Our Ref: 20-12/001182
CRC Ref: mcuc 2021_4490/1
Date: 18 March 2022

RE: RESPONSE TO INFORMATION REQUEST IN RELATION TO AN APPLICATION FOR MATERIAL CHANGE OF USE FOR 'MULTIPLE DWELLINGS' AND 'SHORT-TERM ACCOMMODATION' OVER LAND AT 69 – 73 MURPHY STREET, PORT DOUGLAS

We hereby provide the following information in response to Council's Information Request dated 22 December 2021.

J

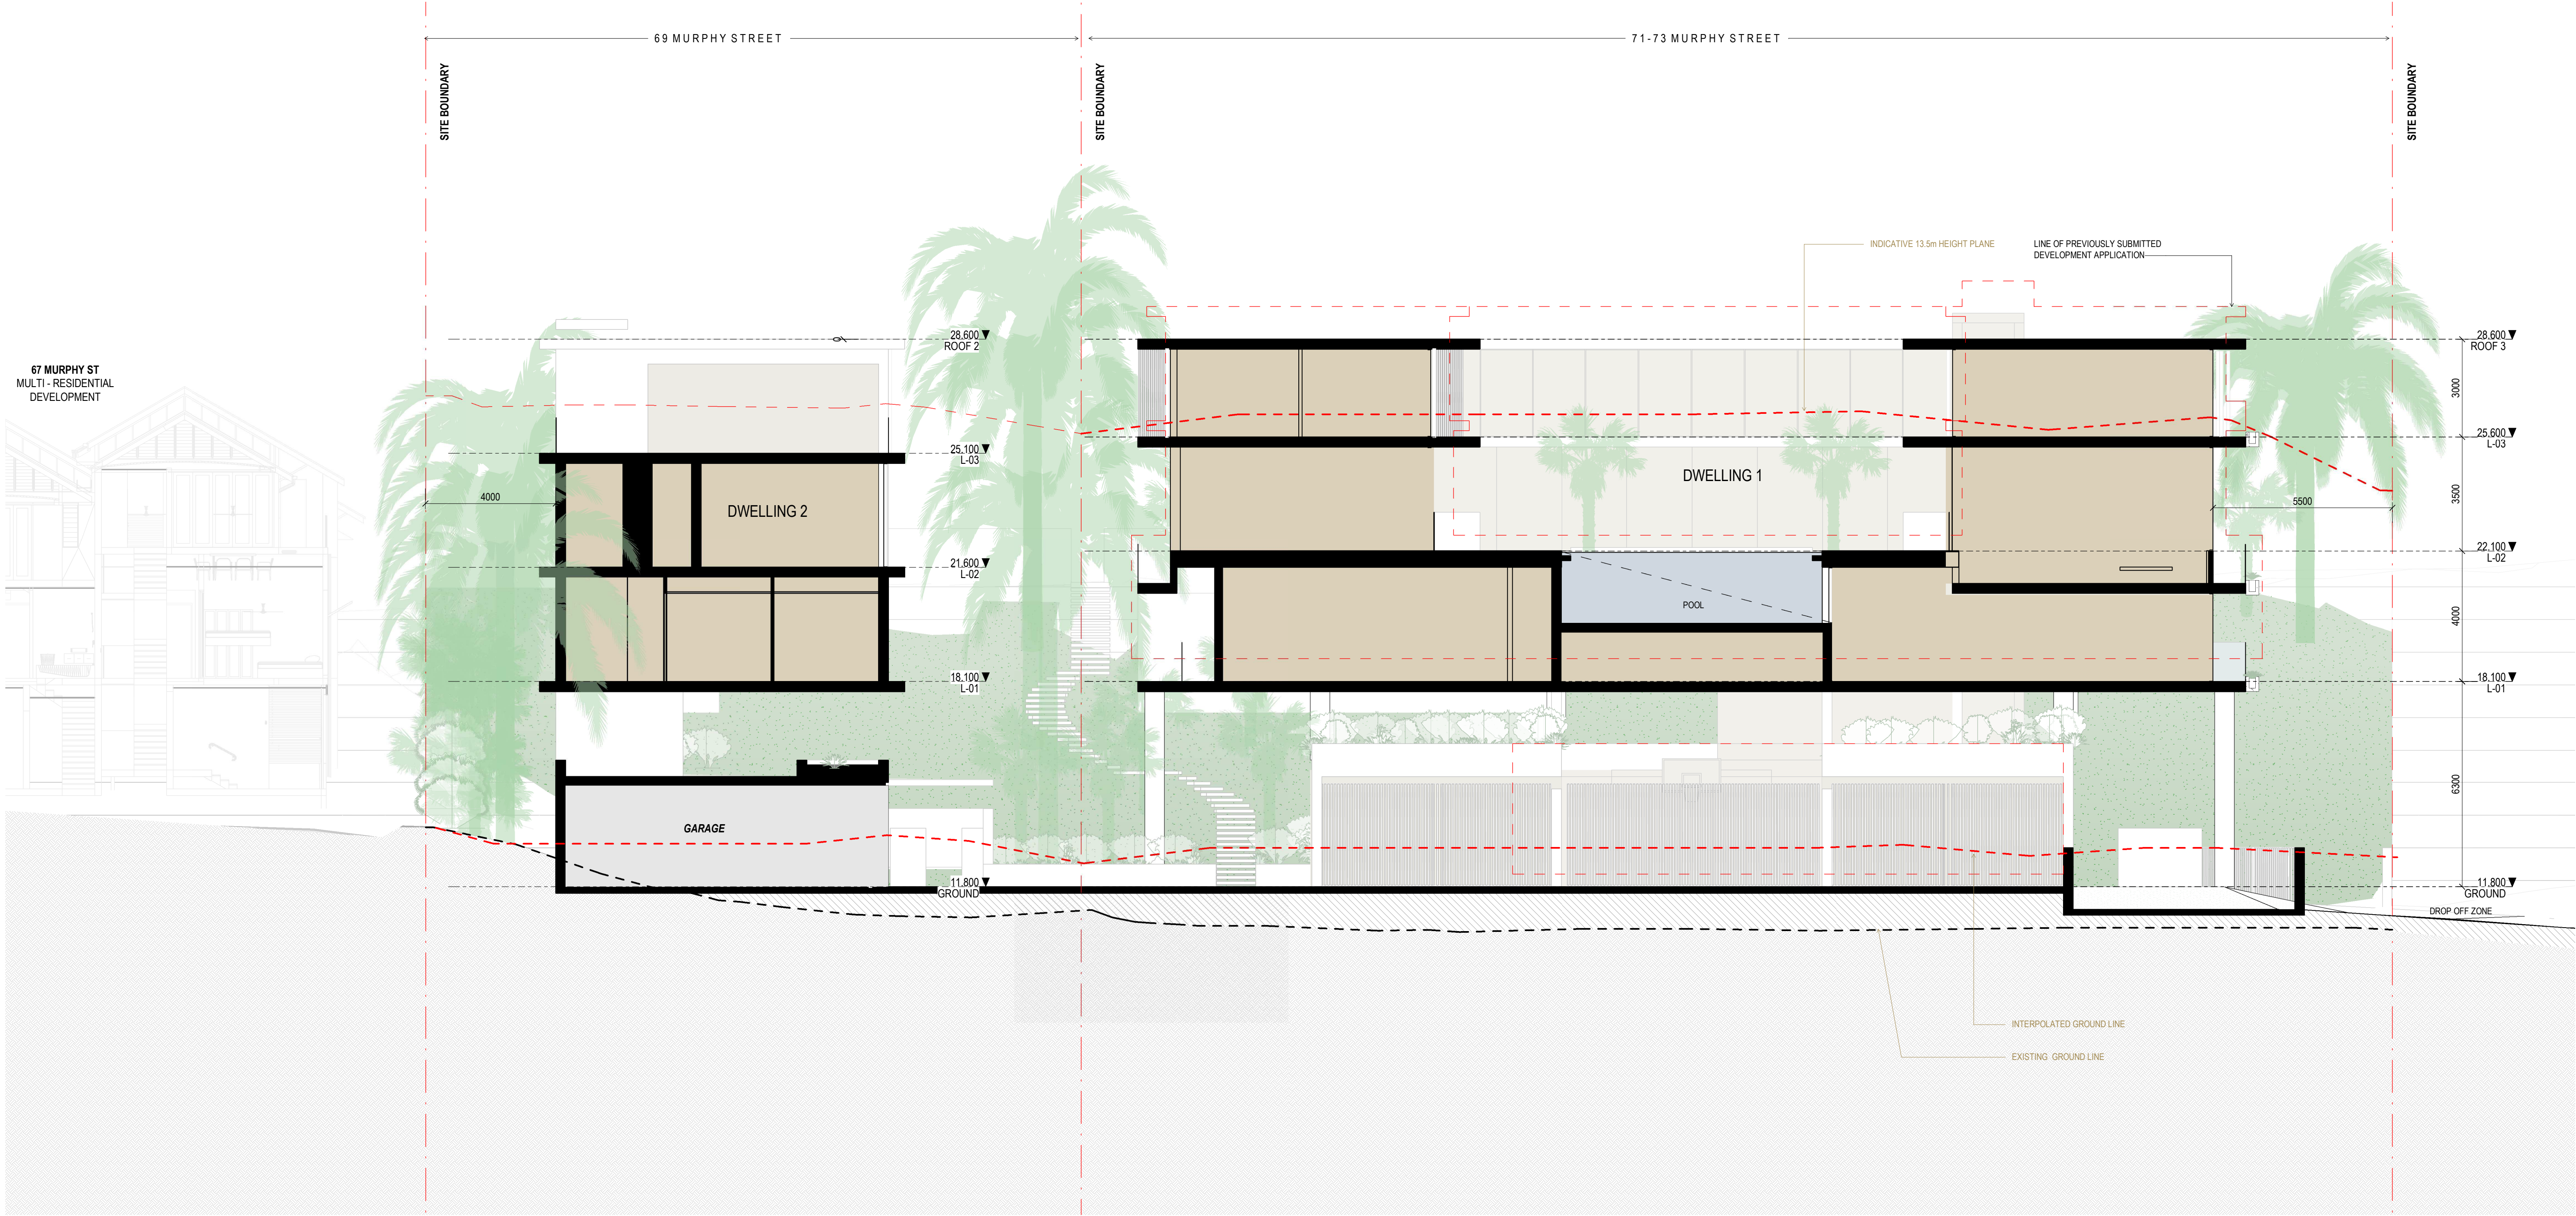
6. Drawing DA010.03 (Ground floor plan) and Sections 1 and 2 on Drawing DA30.001 indicate that the boundary wall adjacent Murphy Street is very close to the property boundary.

Section 1 on Drawing DA30.001 “Typical Sections” shows cut required in the existing batter potentially undermining the road reserve.

Section 2 on Drawing DA30.001 “Typical Sections” shows fill required within the site and extending into the Murphy Street road reserve.

The applicant is to confirm how the walls adjacent Murphy Street are proposed to be constructed and if any disturbance or reliance of Murphy Street is proposed to achieve the development outcome.

7. The applicant is requested to clarify the line-type/hatching used on Sections 1 and 2 on Drawing DA30.001 "Typical Sections" and on the East Elevation drawing DA20.002. Council Officers interpret that the diagonal hatching represents earthworks fill, the applicant is requested to clarify this interpretation.

We refer to the Geotechnical Advice provided by GeoDesign which was included in the Development Application and refer you in particular to the “Stability” section. We note that the existing batter to Murphy Street exhibits stability issues and that the proposed development will rectify these issues in accordance with the geotechnical advice. Structural engineering details for the wall will be sought following approval of final plans and Council may condition the provision of this information prior to obtaining Building Works approval. The proposed construction of these elements are noted on the Architectural plans prepared by Warren & Mahony Architects included as **Annexure 1**

- Legend has been added to sections – hatched pattern is indicative fill.
- Eastern boundary fence shown on Drawing DA20.002 is to follow the ground line and is nominally 1.8m high.
- Pool sections have been added (Drawing DA30.003) – these are a combination of suspended slabs and being cut into existing ground.

Revision
F

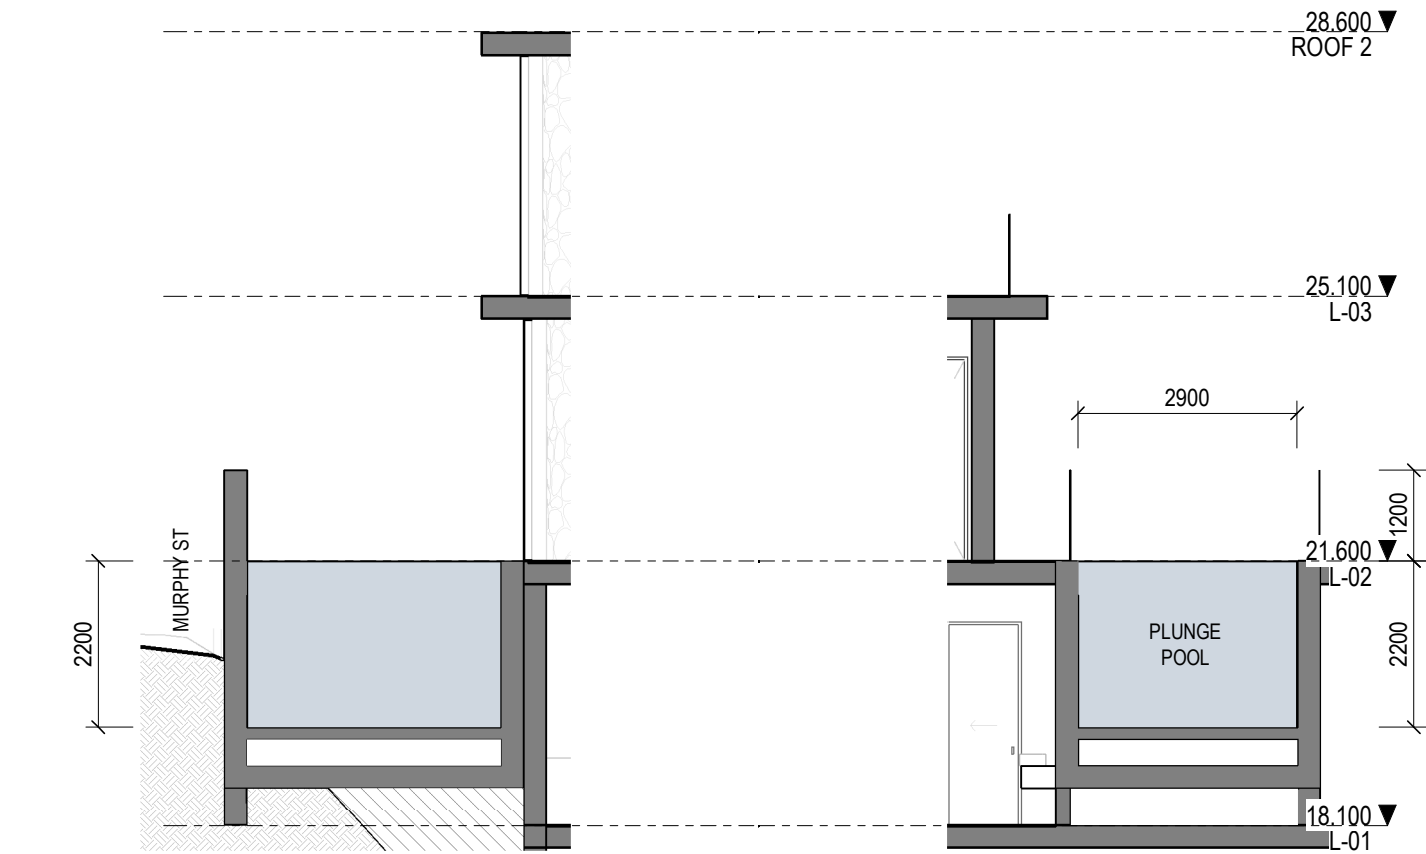
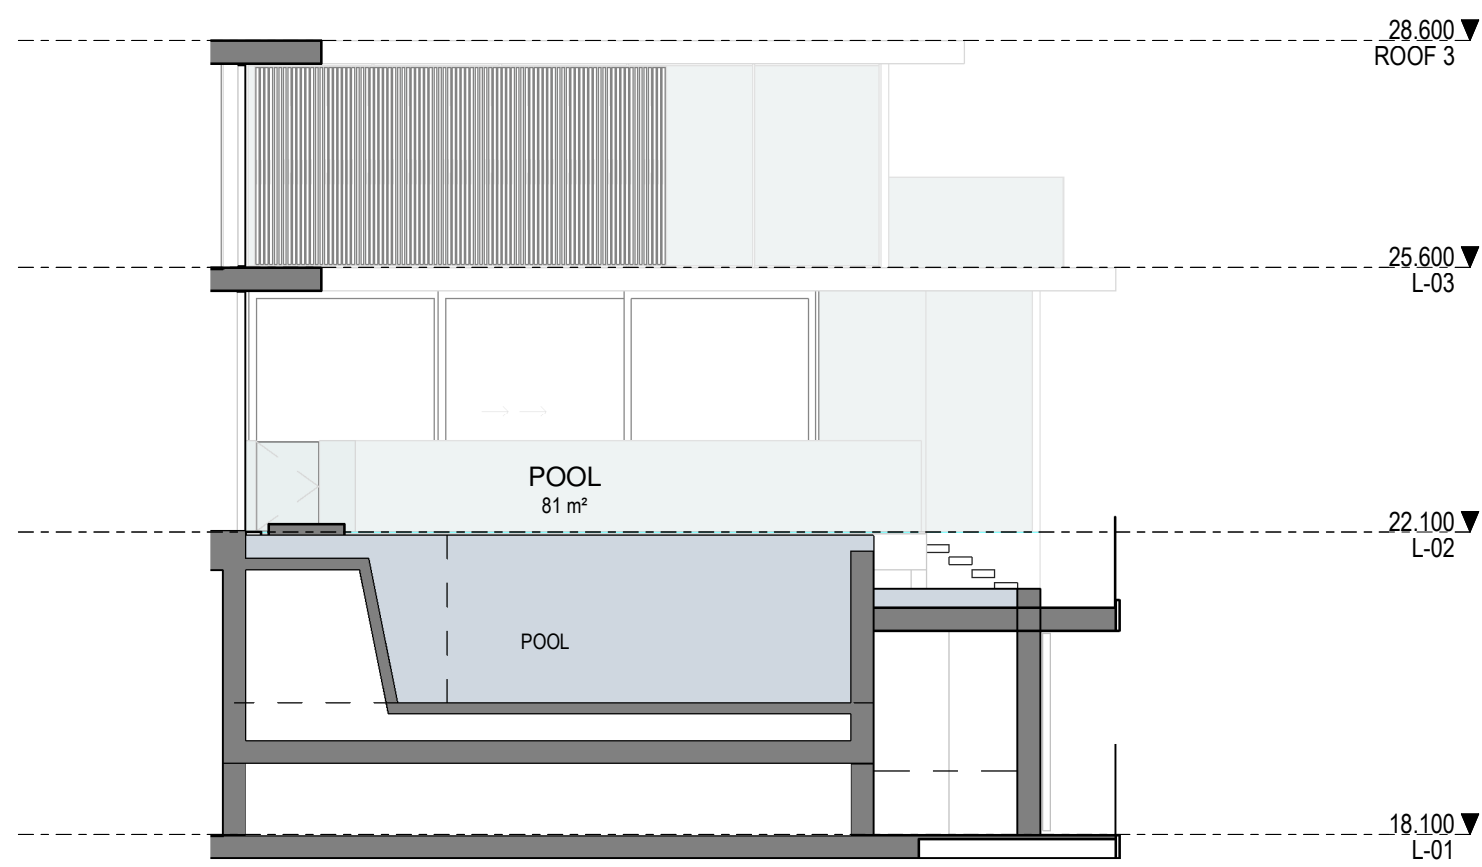
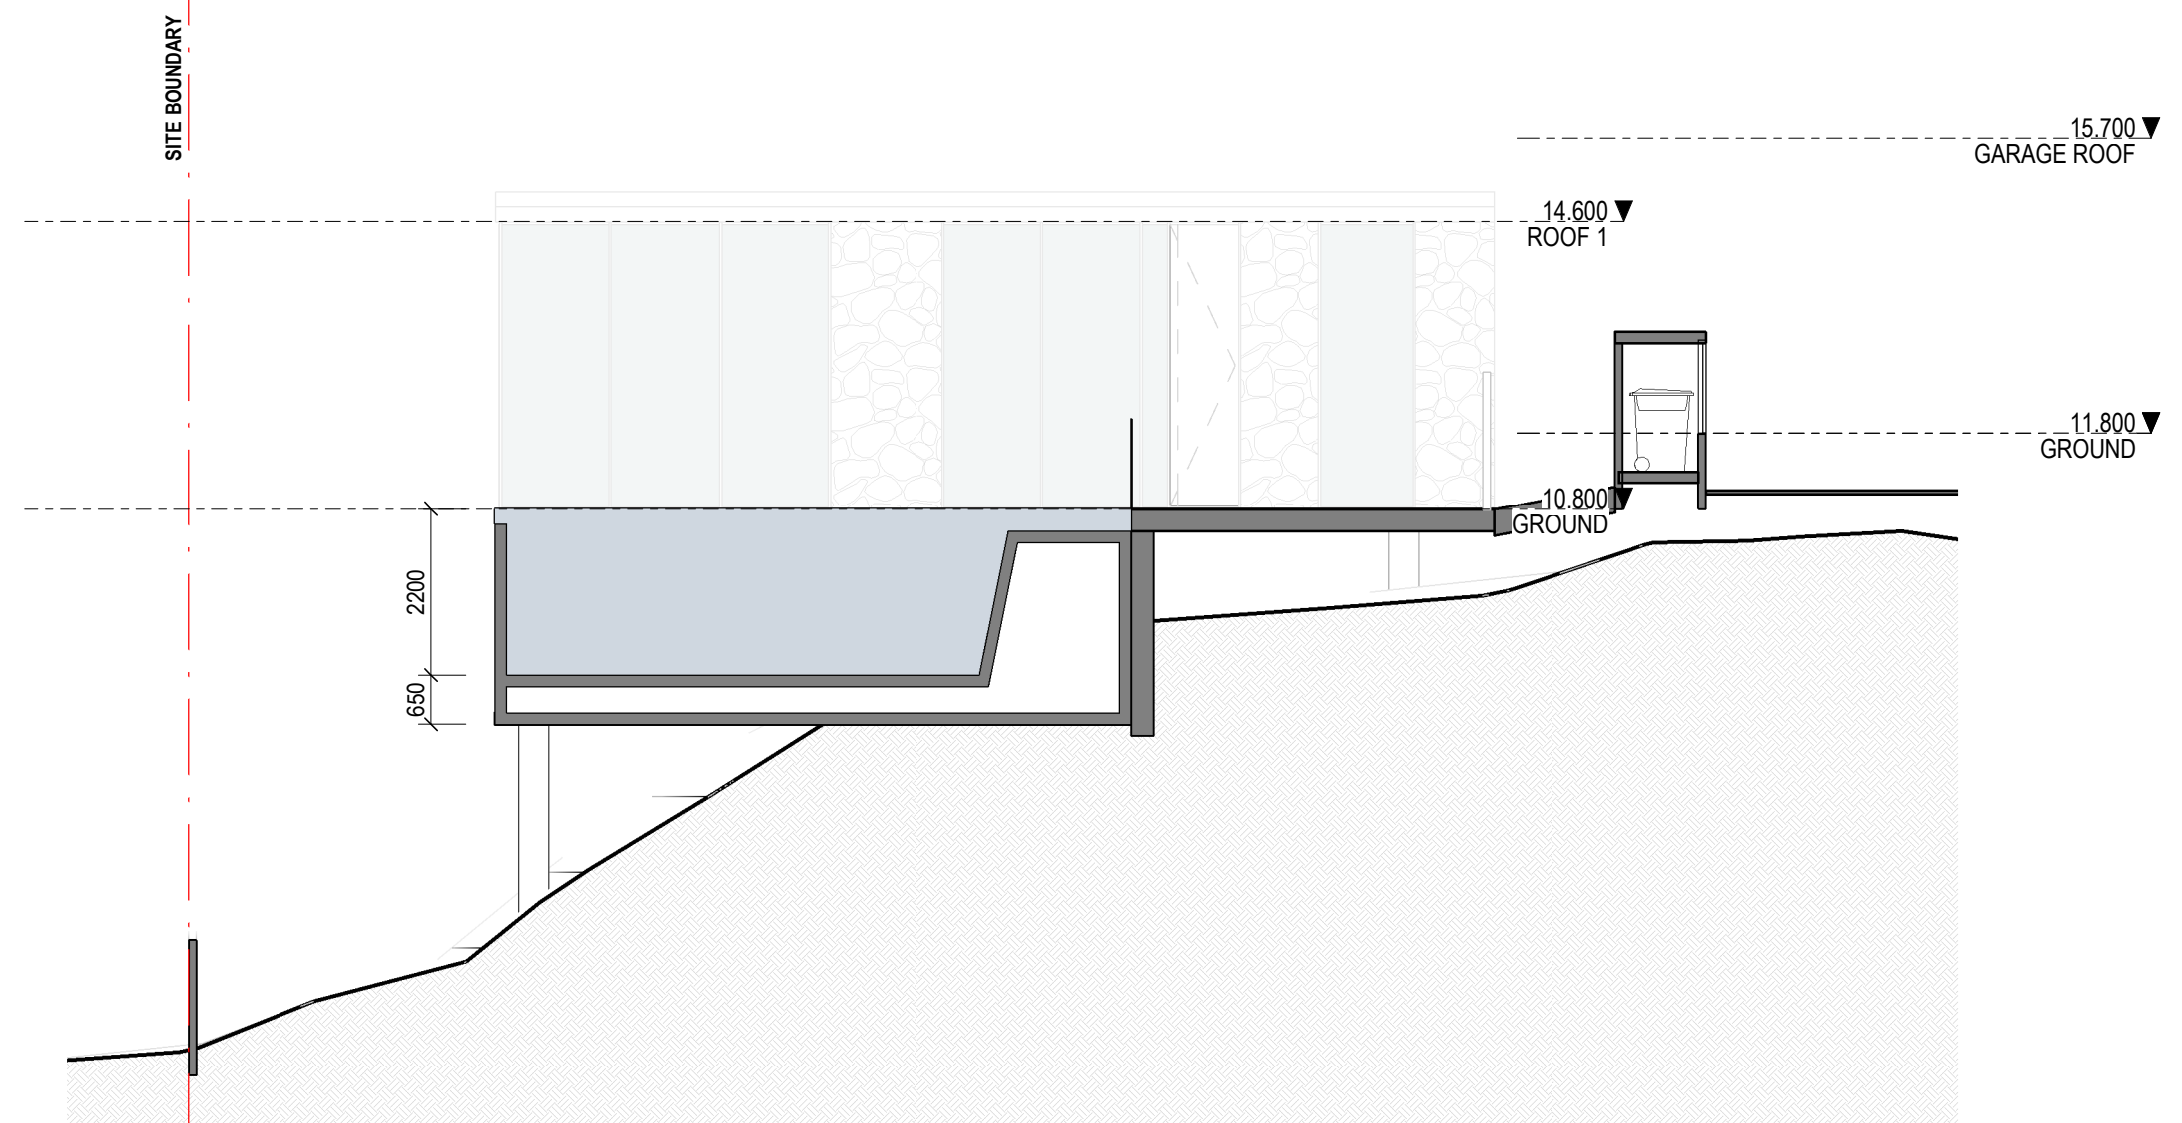
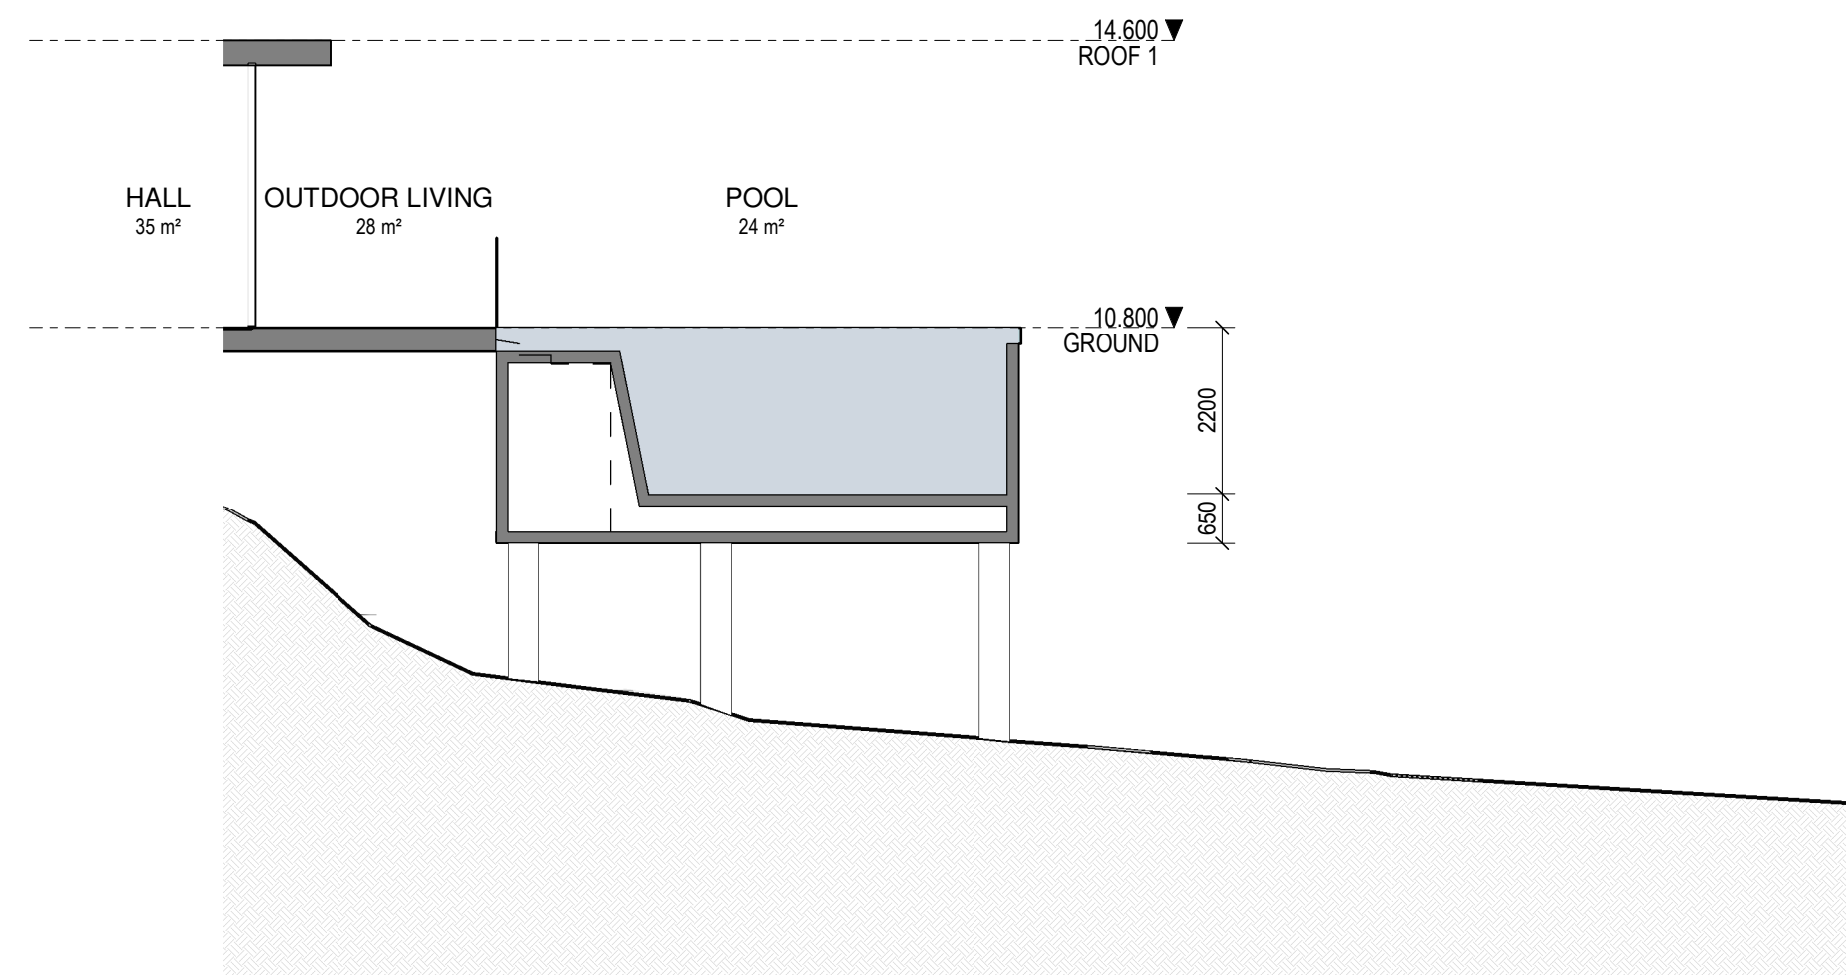
Additional sections through the proposed pools for each dwelling are requested to confirm the founding levels and whether the pools are founded on existing ground, founded in new filling, or suspended above the ground.
